**Mark B. Bezilla**  
Site Vice President724-682-5234  
Fax: 724-643-8069April 2, 2003  
L-03-057U. S. Nuclear Regulatory Commission  
Attention: Document Control Desk  
Washington, DC 20555-0001**Subject: Beaver Valley Power Station, Unit No. 1  
BV-1 Docket No. 50-334, License No. DPR-66  
Reply to Request for Additional Information Regarding  
Order EA-03-009 Relaxation Request**

**Responses to NRC Questions  
Regarding Beaver Valley Power Station (BVPS) Unit 1  
Order EA-03-009 Relaxation Request**

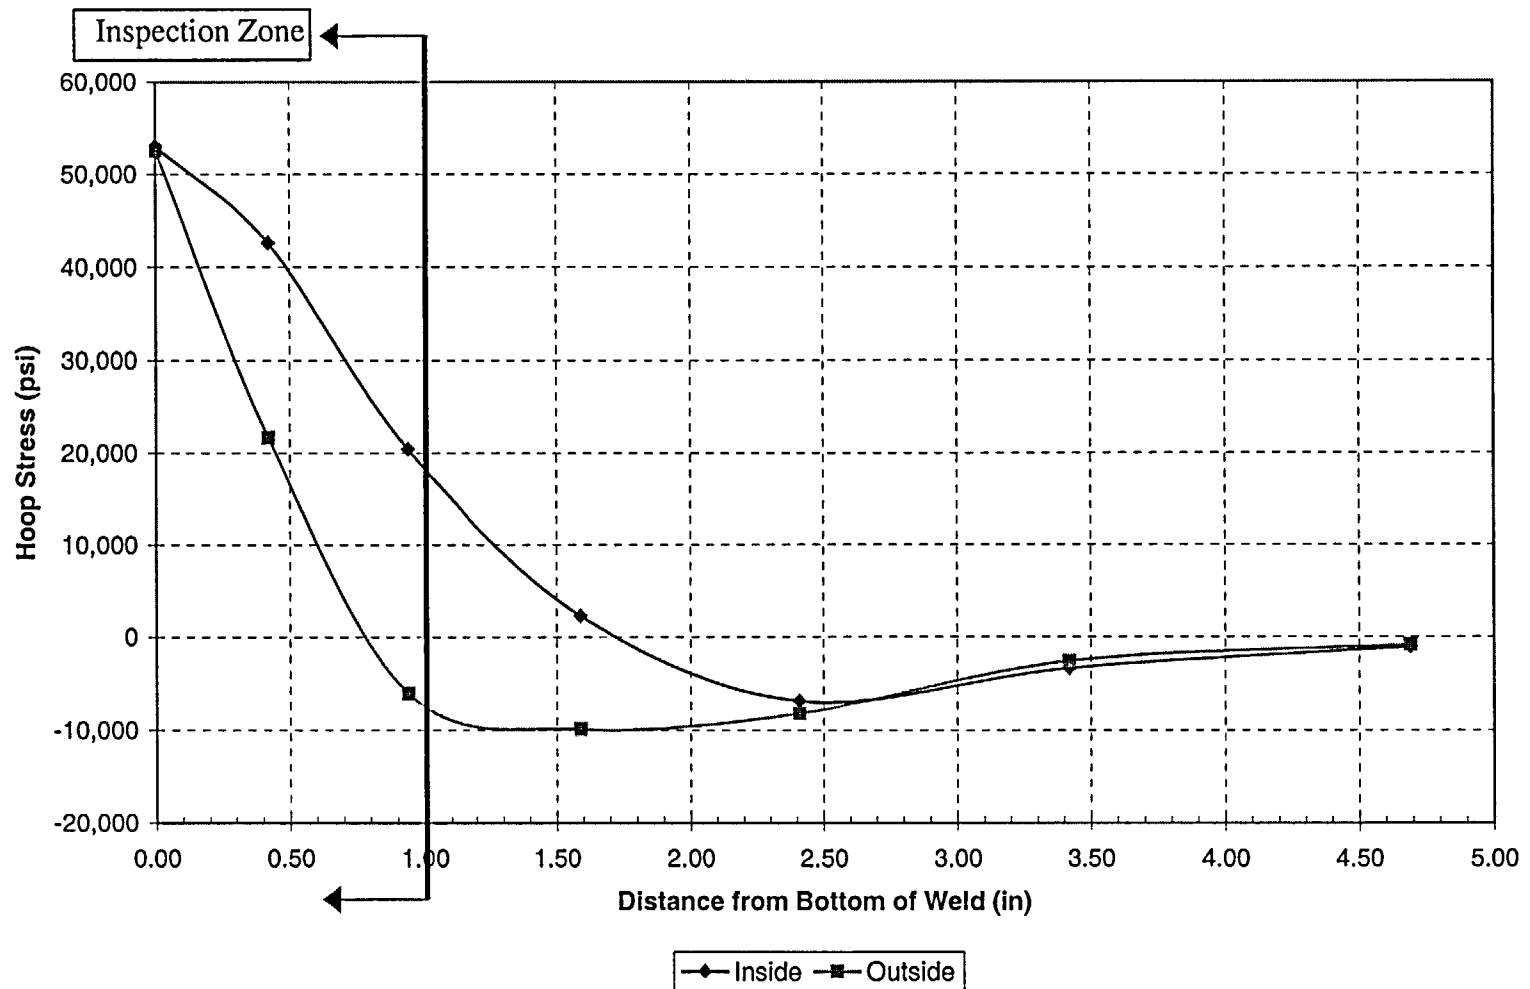
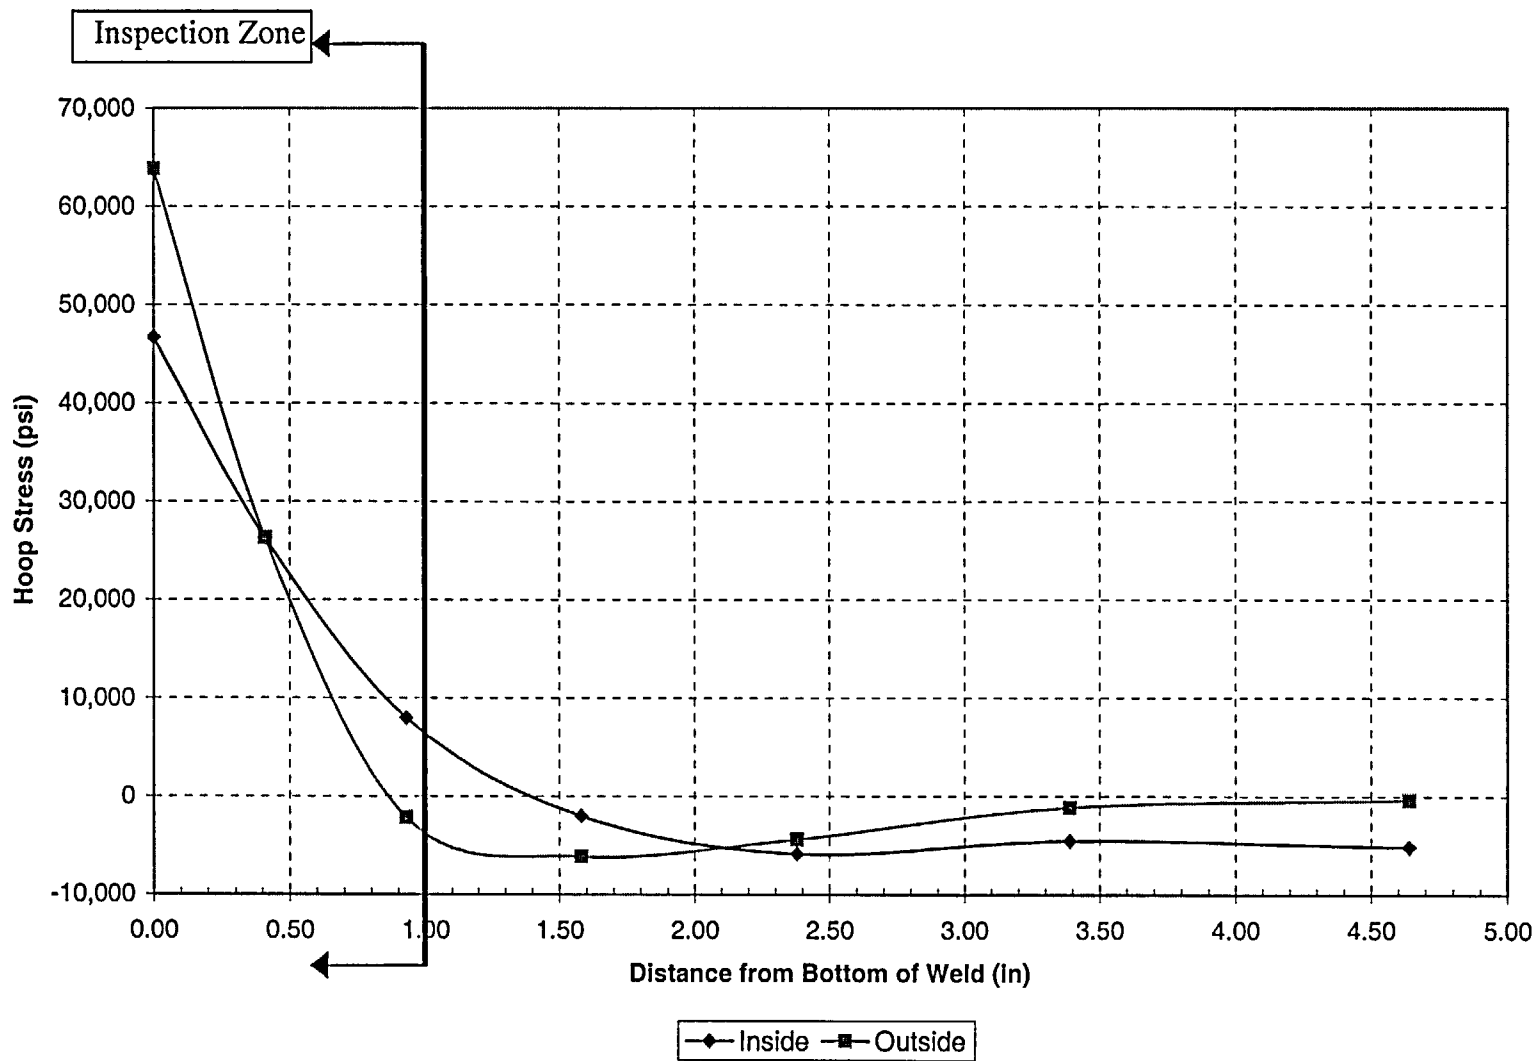
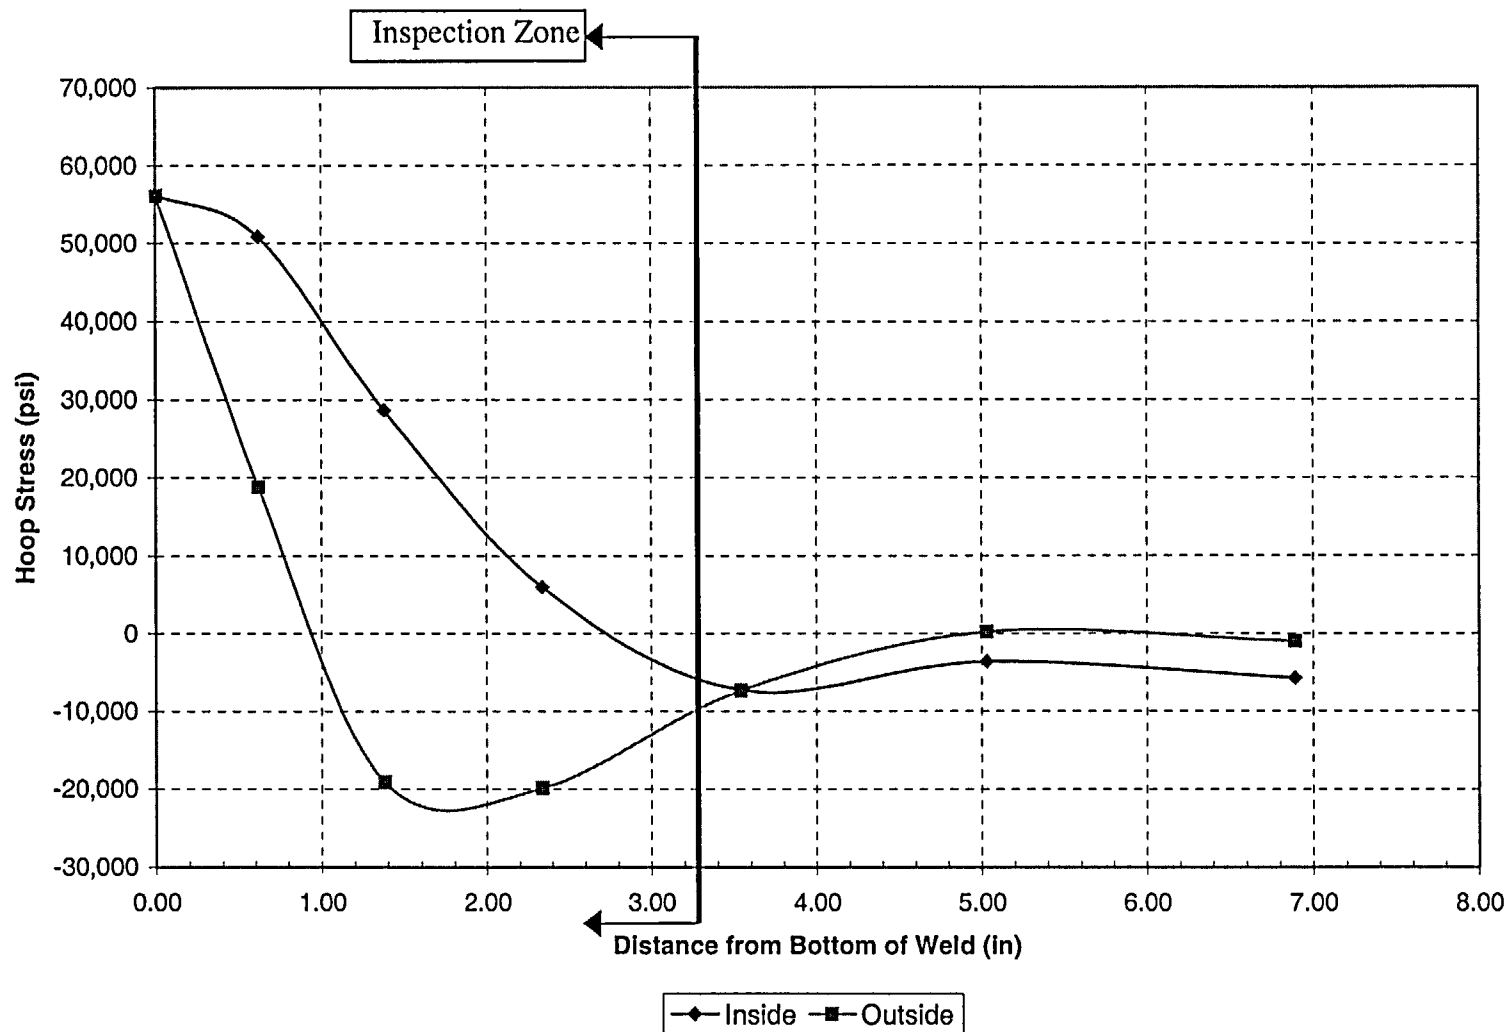
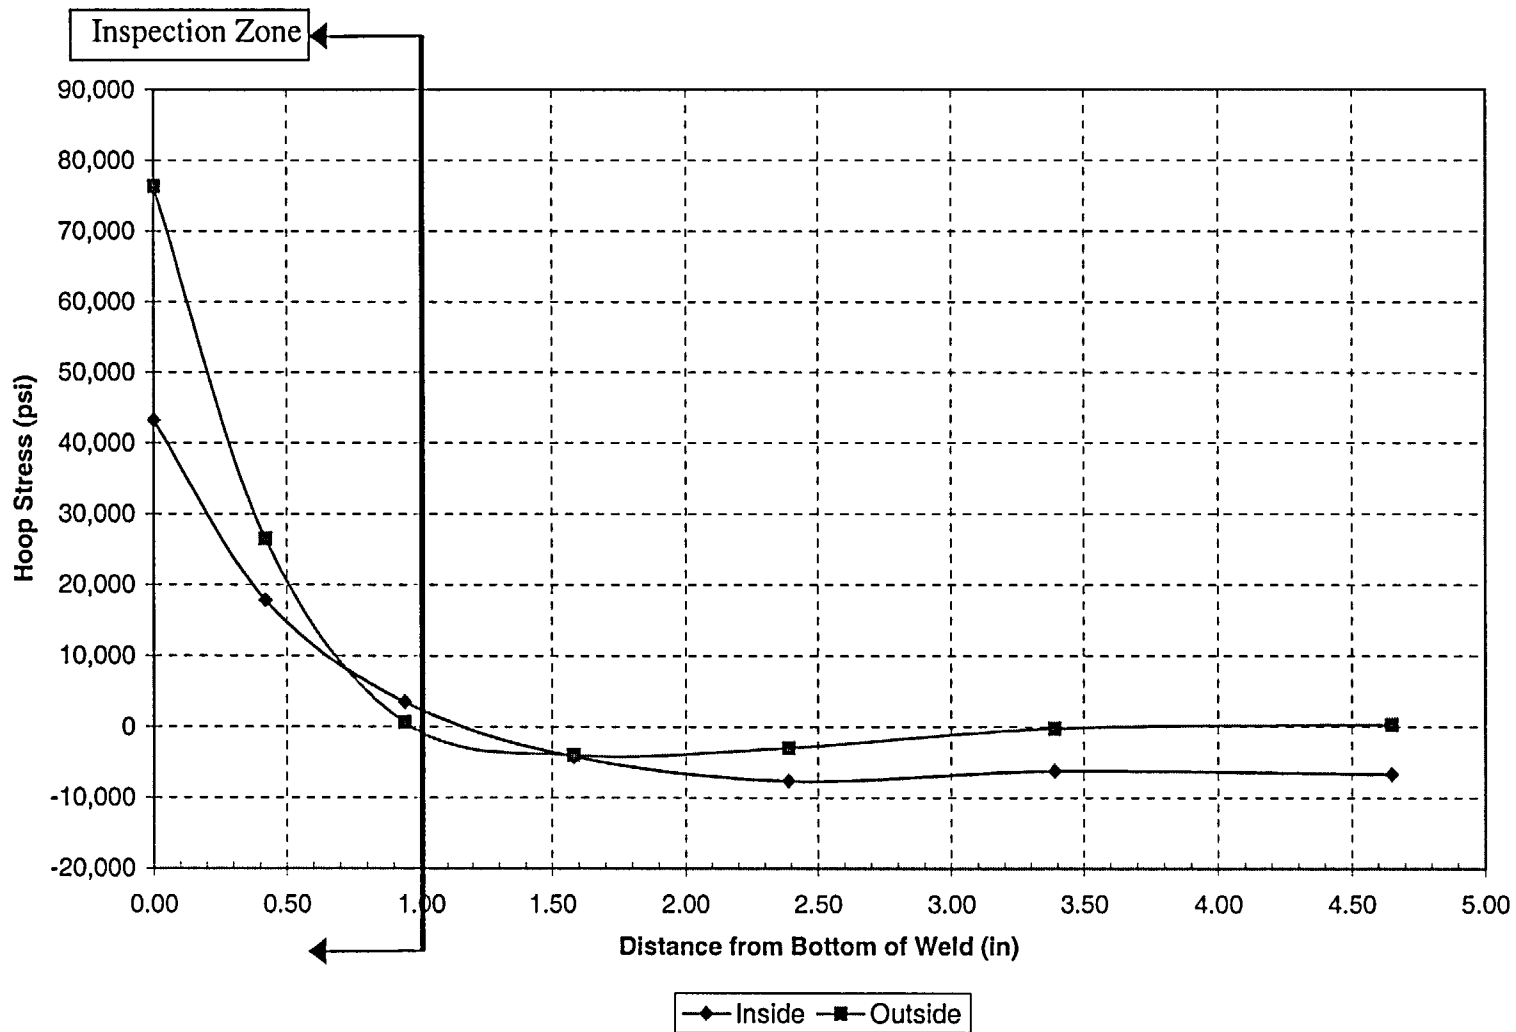
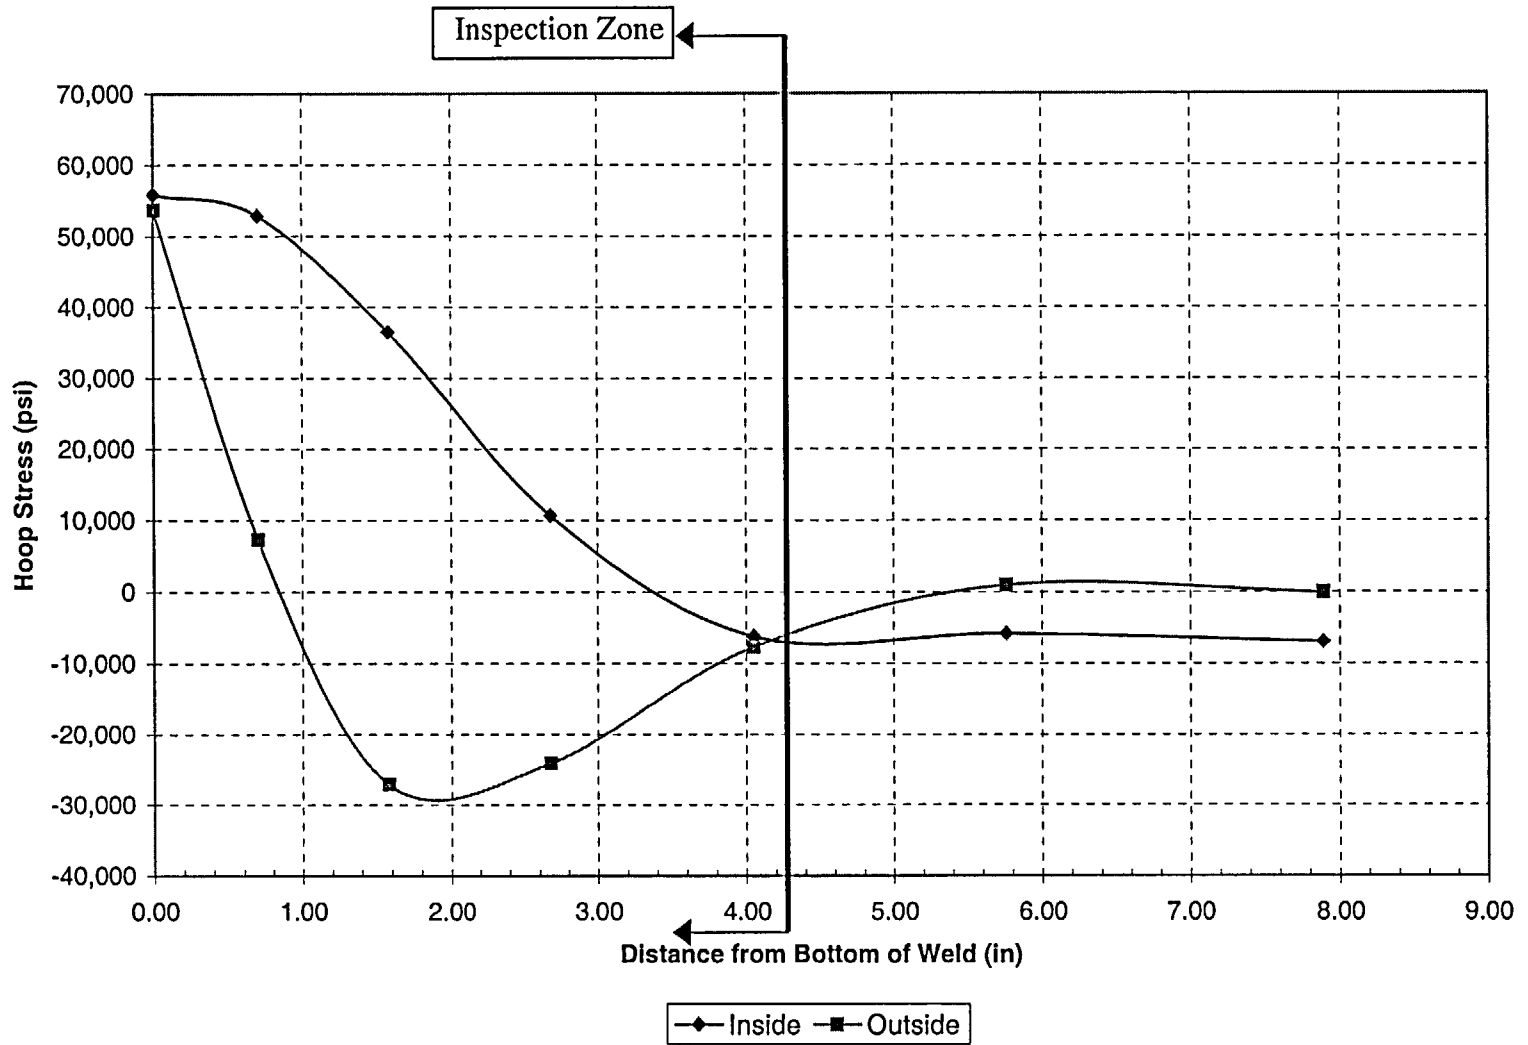
**Question 2.** *The request states that, "The magnitude of the stresses in these portions of the nozzles is low based on information from other plants of similar design and construction." Discuss how this information is applicable to your plant. Provide tabular listings of the maximum stress in the cross-section from the top of the J-groove weld region to the area covered by your relaxation request.*

The hoop stress distributions as a function of distance from the bottom of the weld for a range of penetration nozzles located at the center of the vessel head to the outermost nozzles are provided in Figures 1 to 9. The expected "inspection zone" is also identified in each figure. This information is provided in graphical versus tabular format. As shown in Figures 1 to 9, the magnitude of the stresses in the unexamined portion of the nozzles is low. See response to Question 3 for further information.
